My Viewpoint
Bill Grant

To; Auburn Planning Commission & City Council
Re; Baltimore Ravine Access Alternatives

B.R.S.P.
Alternative Access Locations
Herdal Drive - # 1
Indian Rancheria Rd - # 8
West of Thousand Oaks - # 9

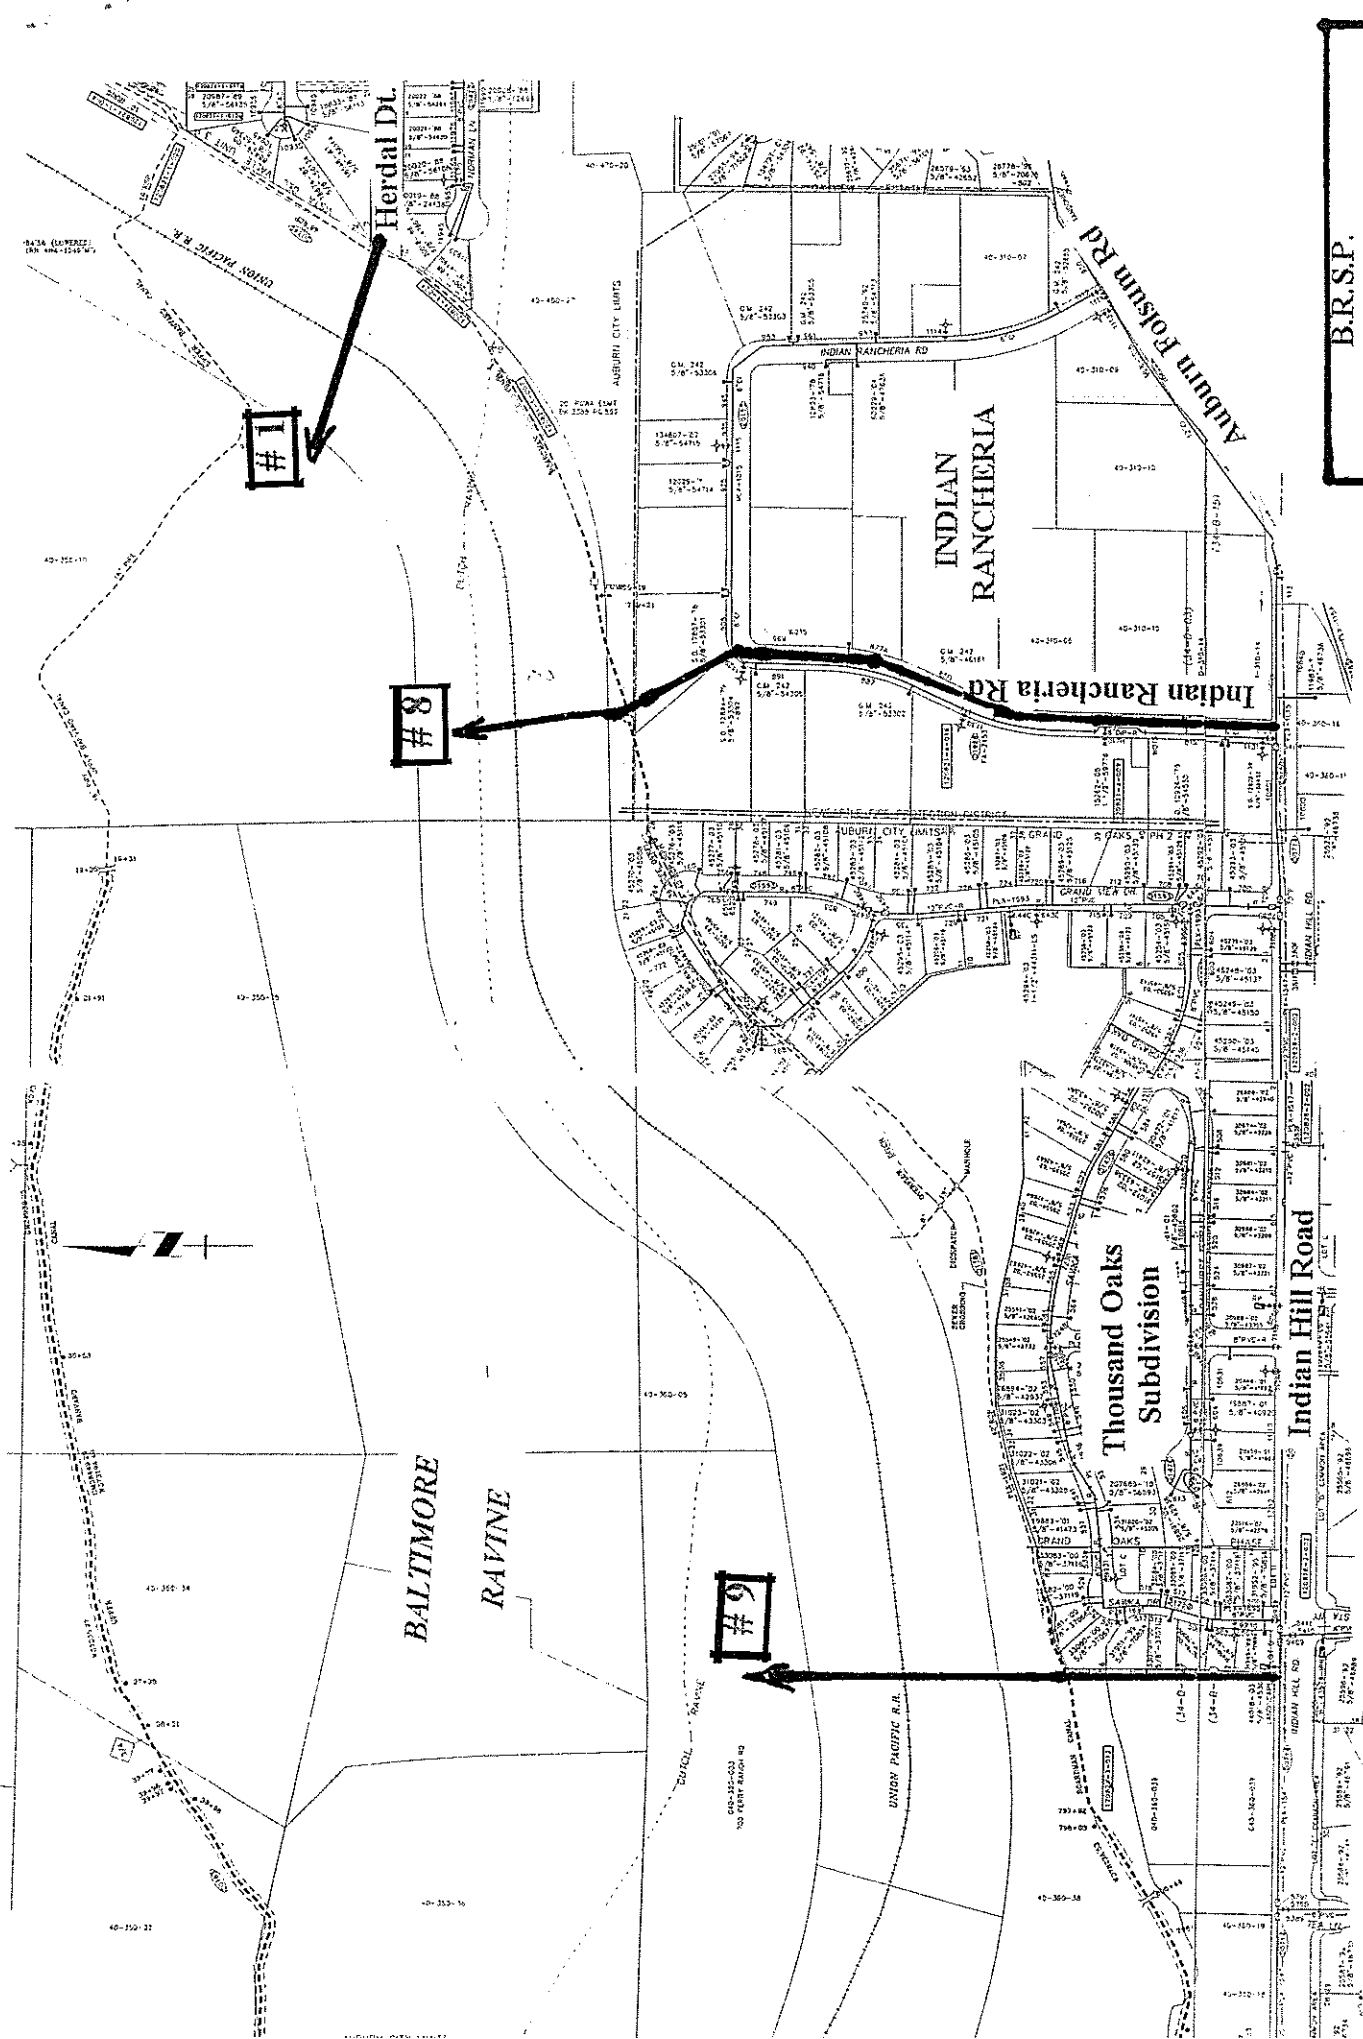
However the authors of the EIR were remiss in failing to specifically identify three other options. These are located at Baltimore Road, Indian Rancheria Rd and Indian Hill Road – west of the Thousand Oaks Subdivision. I have assigned these sites # 7, # 8 and # 9.

7 -Baltimore Road This is an existing private road off Palmyra St. It originally served a Ranch in Baltimore Ravine. Now there are 4 or 5 homes along this road, as well as a small 7-8 lot subdivision on Knollwood Drive, which branches off of Baltimore Road. It would be a challenge to upgrade this road to City standards. But this is the ONLY route into Plan Area 1 that does NOT cross the railroad. No railroad bridge required !

8 - Indian Rancheria Road This option would utilize about 1000 feet of the west leg of Rancheria Road off of Indian Hill Road. About 10-12 subdivision lots would be impacted along this length.. From there a new route would traverse northerly between two lots and across the railroad. I have no information on the terrain in this area..

9 – Indian Hill Road. This option starts at Indian Hill Road, and runs parallel to the westerly boundary of the ^{Thousand} Auburn Oaks subdivision. It would continue northerly and go across the Railroad into the Ravine, ending somewhere in the vicinity of the Perry Ranch Road. This location would probably require about 1,000 feet of roadway; but I have no information on the terrain. The effect on existing residents appears to be minimal.

I believe that the City officials should seriously review these additional options, before adopting and certifying the EIR. I would also suggest that consideration be given to substituting an Indian Hill access option for the Werner Road / Ophir Drive location. The Werner Road route is an inadequate, awkward, unsafe and misguided choice. It will lead to problems and difficulties to implement and maintain. And it still would not provide a safe, convenient and suitable route in or out of the Baltimore Ravine. The BRSP area would be better served with both an access off Indian Hill Road (# 8 or #9) and access at Herdal Drive or one of the other nearby options (#4,#5,#7). I strongly urge Auburn to adopt this plan, or a similar one with dual access locations excluding the Werner / Ophir Road route. These various options are shown on the two attached maps.
